BEFORE THE DUNEDIN CITY COUNCIL

Land Use Consent Application to
construct and operate a commercial
residential development by NZ
Horizons Hospitality Group Limited.

STATEMENT OF EVIDENCE OF ANDREW DAVID CARR
Transportation
24 July 2017

Annexure A: :Levels of Perimeter Roadway within the Site (Extracted from Site Cross-Sections)

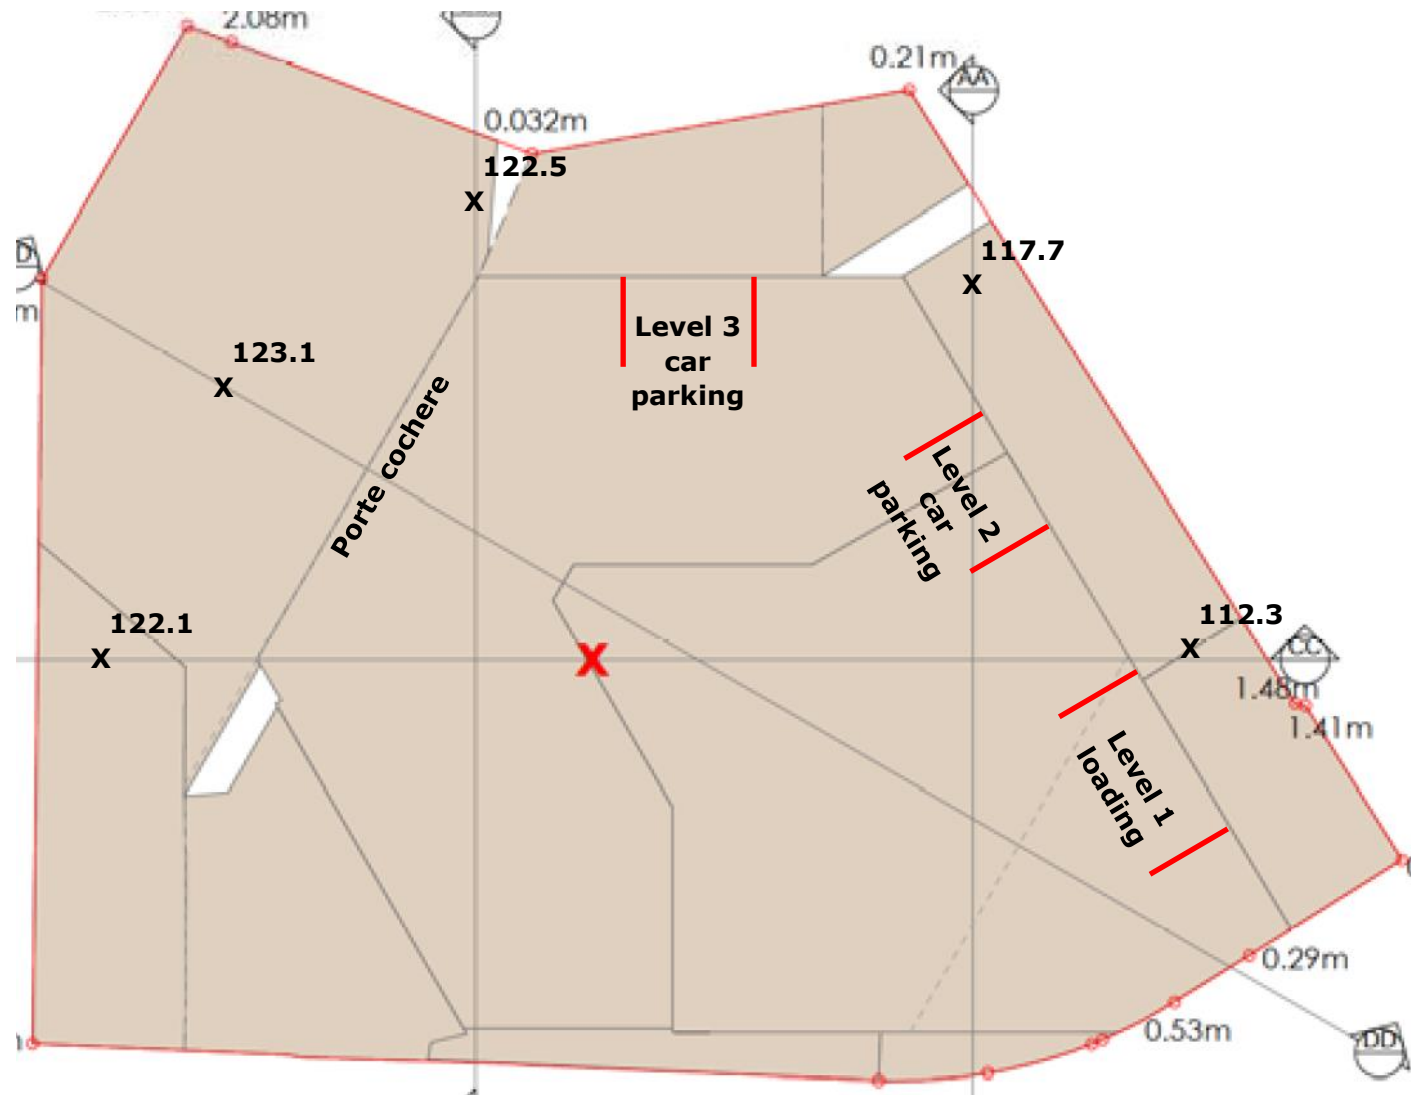
- 24 Since the application does not provide the information, I have assessed the ramp gradients on the perimeter roadway. In producing this, I firstly identified the levels of the perimeter roadway based on the cross-sections provided, and these are plotted on the plan shown in Annexure A. It can be seen from this that the level of Level 4 corresponds to the level shown directly outside the porte cochere (RL 123.1).

Annexure B: Levels of Perimeter Roadway, and Locations of Parking/Loading Accesses within the Site

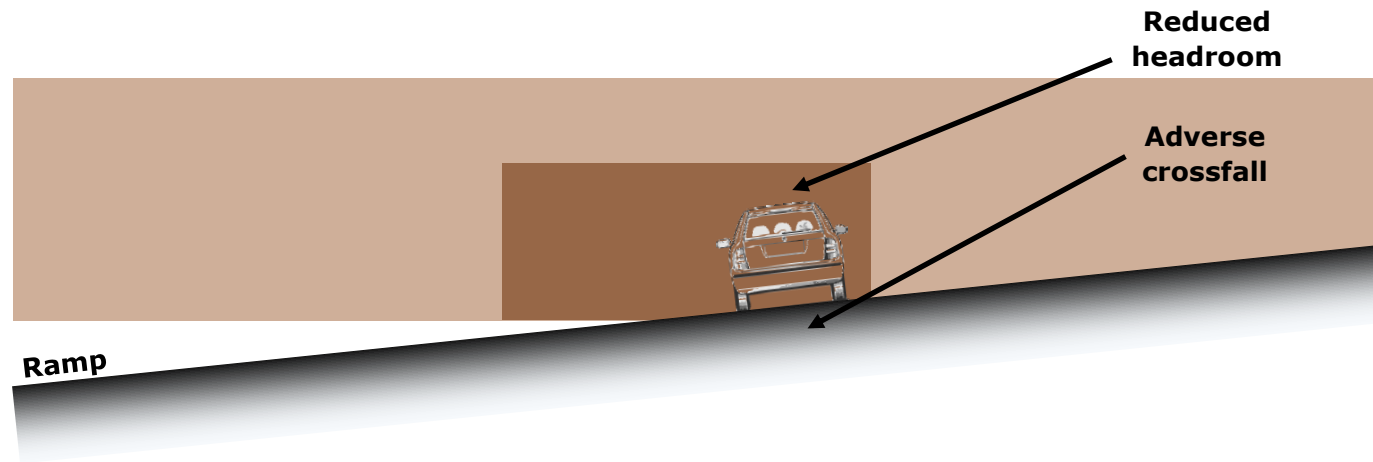
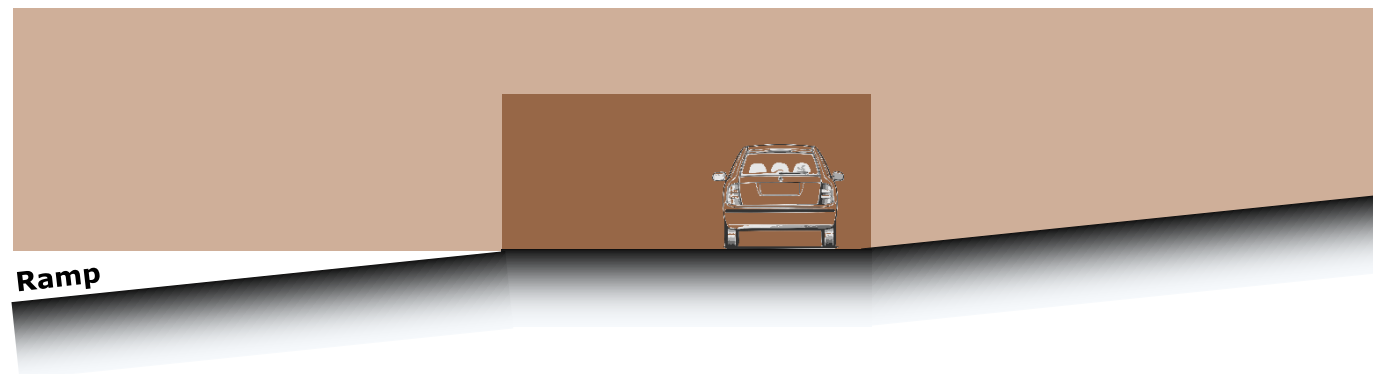
- 25 I next added the locations of the entrances to the car parking and loading bay, and these are shown on Annexure B.
- 26 I then identified the levels of the perimeter roadway immediately adjacent to the accesses into each level of the building. One important element of this is that the perimeter road must be almost flat as it is adjacent to the accesses. This is firstly because as the vehicle turns to/from the access, they are travelling at 90-degrees to the perimeter roadway. This then means that the perimeter roadway gradient becomes the access crossfall², and at high crossfalls vehicles can become unstable. The second reason for the gradient of the perimeter

Annexure C: Illustration of Problems Associated with Steep Ramps at Accesses

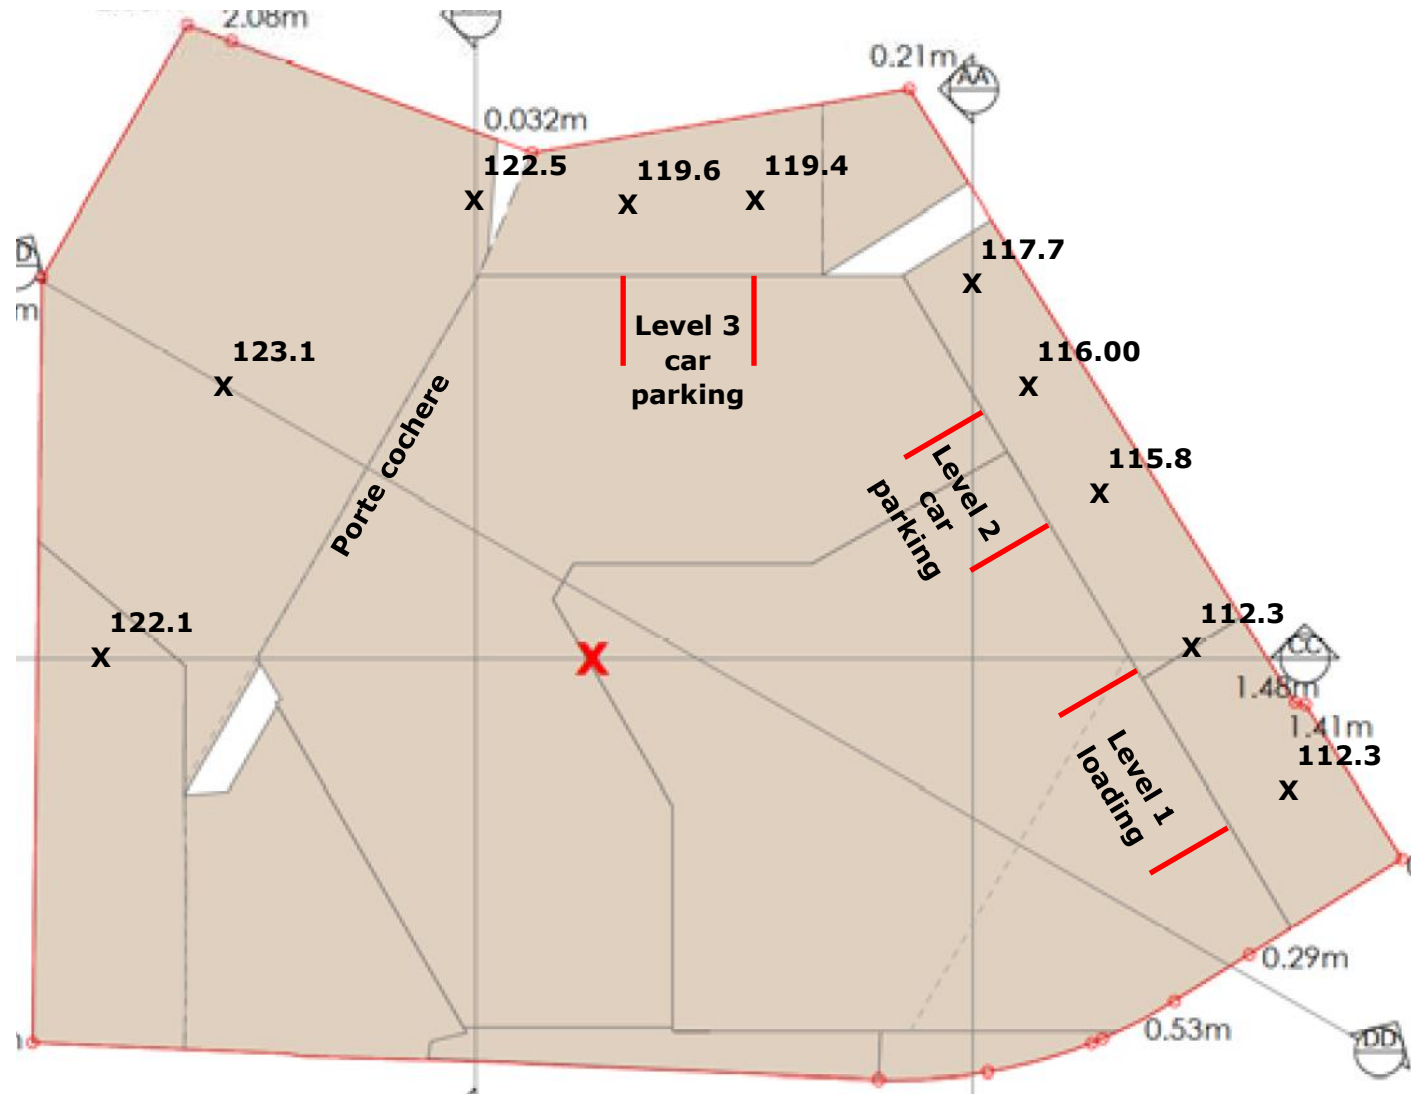
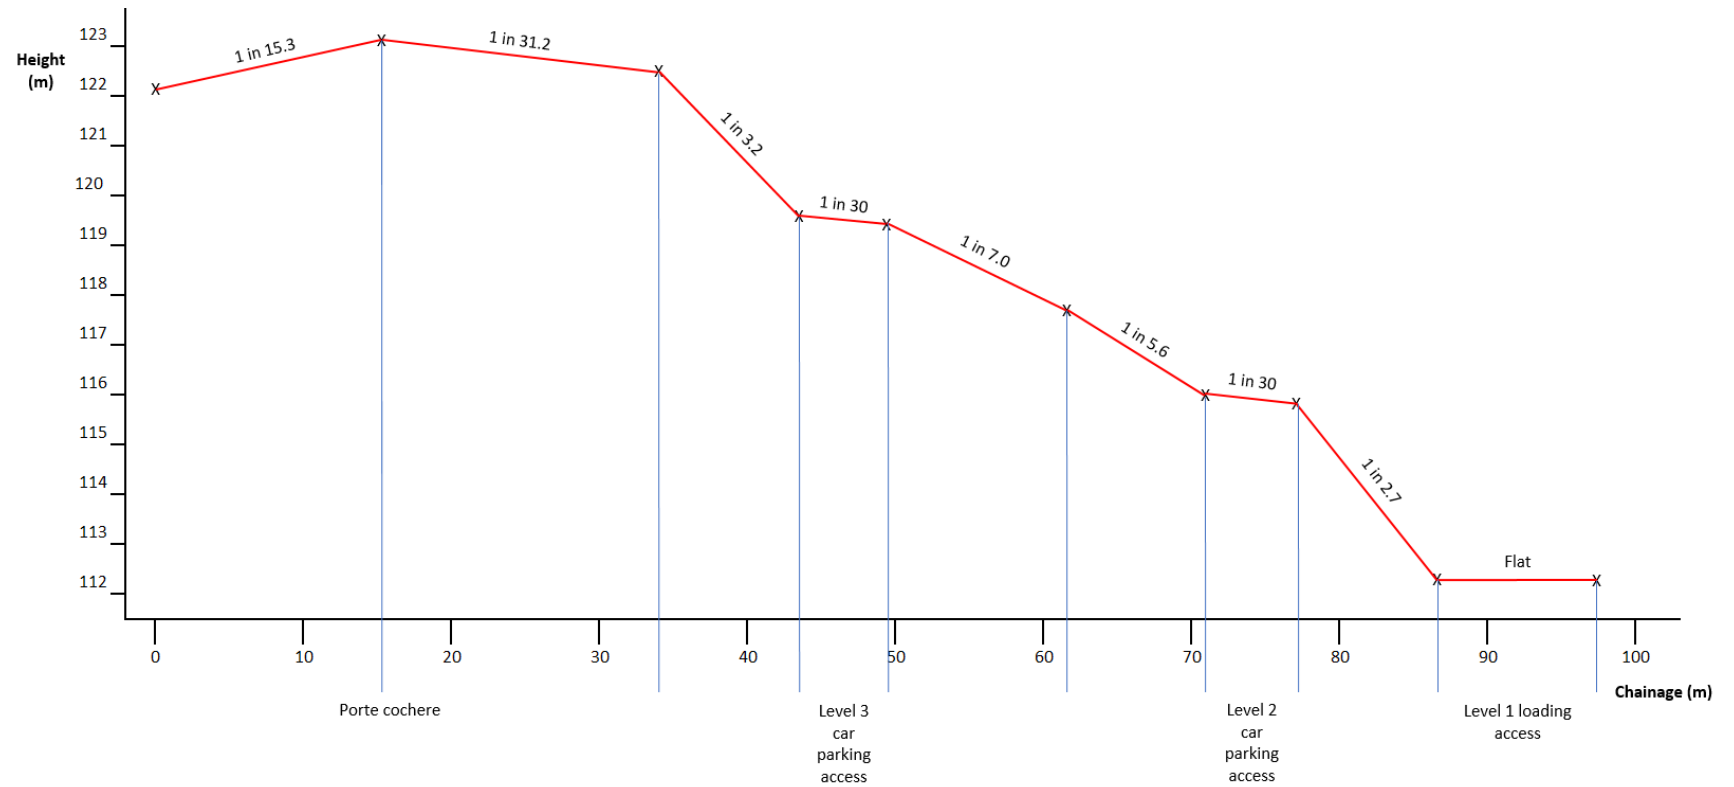
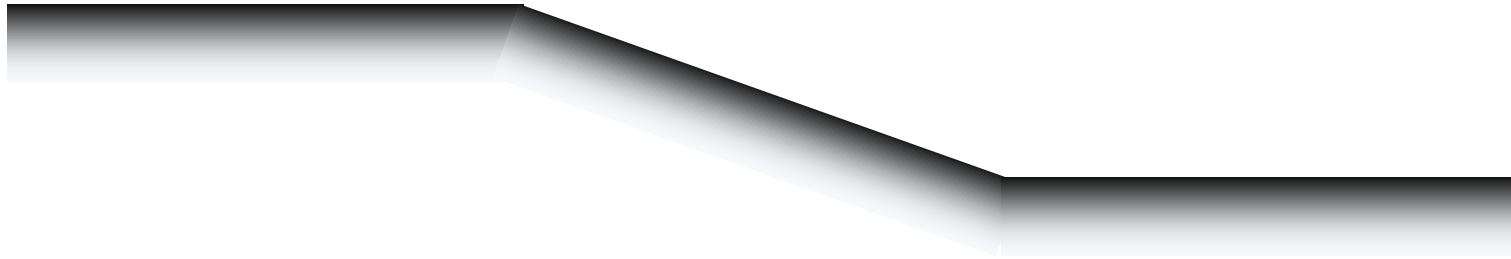
roadway needing to be relatively flat at the access is to ensure that there is sufficient headroom available. These issues are illustrated on Annexure C.

Annexure D: Levels of Perimeter Roadway, and Parking/Loading Accesses within the Site

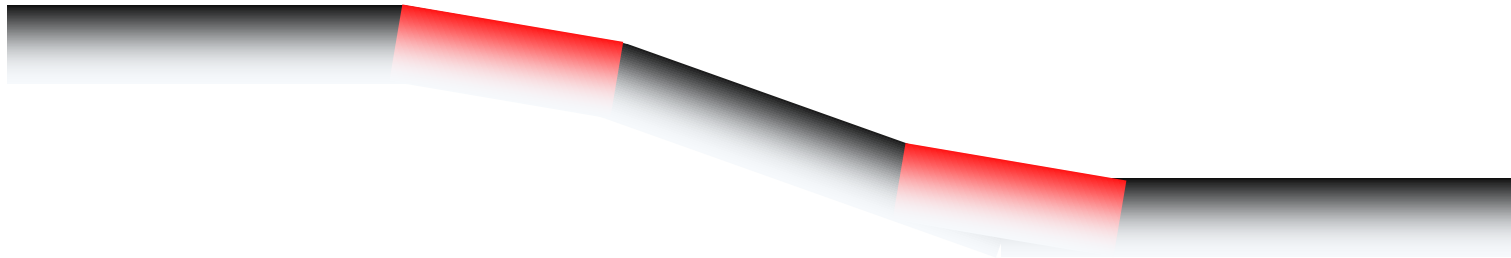
- 27 In practice a slight gradient is maintained to assist with drainage, and I have made allowance for this. The levels at the perimeter roadway at the accesses into each floor of the building are shown on Annexure D.
- 28 With the levels plotted in this way, a long section can then be produced for the perimeter roadway as it passes around the building, and this is shown on Annexure E. I have also calculated the gradients of the various sections of the perimeter roadway, and these are shown also. For clarity, the only information presented on Annexure E is that which can be found within, or is calculated from, the application itself - I have simply presented it in a different manner.
- 29 I discuss the implications of the gradients subsequently in this evidence.

Annexure E: Long Section of Perimeter Roadway

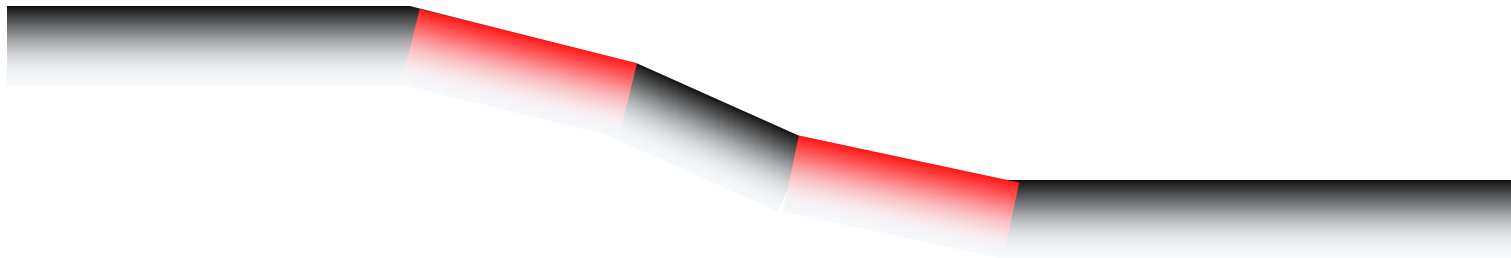
- 39 Considering firstly private cars, the long section of the perimeter shows that the requirements for the maximum changes of gradient are not met. This non-compliance with Rule 20.5.7(iv)(e) of the operative District Plan has not been identified in the application.

- 40 Moreover, the extent of the non-compliance is considerable. For instance, travelling between the porte cochere and the car parking on Level 3, the gradient changes from 1 in 32.1 to 1 in 3.2, which is a net change of gradient of 1 in 3.7. This is more than twice what is permissible under the District Plan or the Standard. Travelling from the car park access on Level 2 to the site exit, the change of gradient is even more severe.

- 42 However two of the gradients are already 1 in 3.2 and 1 in 2.7, and these are considerably steeper than the Standard permits. In my view, it is not practical to make them even more steep to accommodate transition ramps. My preliminary calculation shows that the resultant gradients would be similar to those at the limit for specialist off-road 4WD vehicles.
